# Access Compliance Report

## Public Rights-of-Way

Intersection ID: 18189	Main Street: S_WENDOVER_RD	Cross Street: FOREST_DR	Location: S
ADA ID: 3FF65E1C5D22	Ramp Type: PerpDiag	Initial Pass/Fail: Fail	Overall Compliance: No
Severity Score: 12.5			
Codes/Mitigation Info/Possible Solution		Field Measurements/Component Compliance

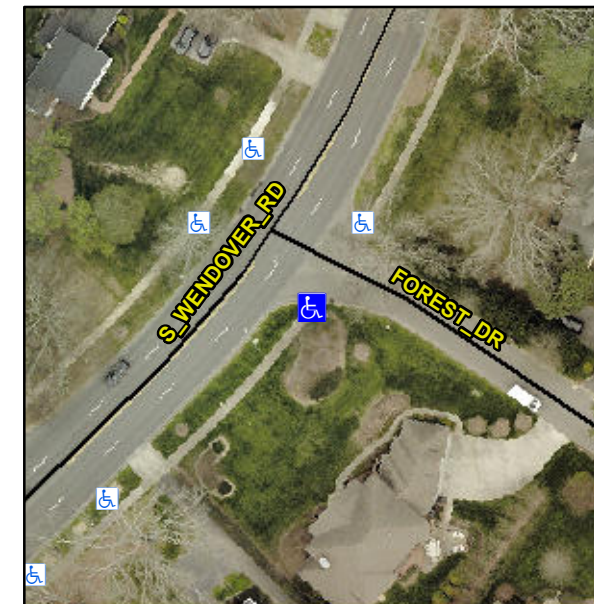
**Not Found, R304.5.3**

Compliance	Description	Data	Compliance	Description	Data
N/A	Ramp Length (in)	62.0	Yes	Ramp Slope (%)	5.1
Yes	Ramp Width (in)	48.0	No	Ramp XSlope (%)	5.4
N/A	Flare Type LT	N/A	N/A	Flare Type RT	N/A
N/A	Flare Slope LT (%)	N/A	N/A	Flare Slope RT (%)	N/A
N/A	Flare Traversable LT?	N/A	N/A	Flare Traversable RT?	N/A
N/A	Landing Length (in)	N/A	N/A	DWS Provided?	N/A
N/A	Landing Width (in)	N/A	N/A	DWS Contrast?	N/A
N/A	Landing Slope (%)	N/A	N/A	DWS Length (in)	N/A
N/A	Landing X Slope (%)	N/A	N/A	DWS Full Width?	N/A
N/A	Landing Curb? (Y/N)	N/A	N/A	DWS Offset (in)	N/A
N/A	Shared Landing?	N/A			
N/A	Gutter Ponding?	N/A	N/A	Gutter Slope (%)	N/A
N/A	Gutter Lip Ht (in)	N/A	N/A	Gutter X Slope (%)	N/A
N/A	Painted X Walk1?	No	N/A	Painted X Walk2?	No
	X Walk 1 Direction	To NE		X Walk 2 Direction	To NW
N/A	X Walk 1 Width (in)	N/A	N/A	X Walk 2 Width (in)	N/A
	X Walk 1 Slope (%)	2.2		X Walk 2 Slope (%)	5.6
	X Walk 1 X Slope (%)	3.8		X Walk 2 X Slope (%)	0.5

N/A	Ramp inside XWalk1?	N/A	N/A	Ramp inside XWalk2?	N/A
	Road Slope (%)	3.8	N/A	Clear Space?	N/A
	Road X Slope (%)	5.1	N/A	Clear Space to XWalk (in)	N/A
N/A	Any Obstructions?	N/A	N/A	Storm Grate/Utility Hazard?	N/A
	Obstruction Type			Storm Grate/Utility Type	
		N/A			N/A
		Yes		Surface Condition? (G/P)	Good

**Remove & Replace Curb Ramp With Two New Directional Ramps or Equivalent.**
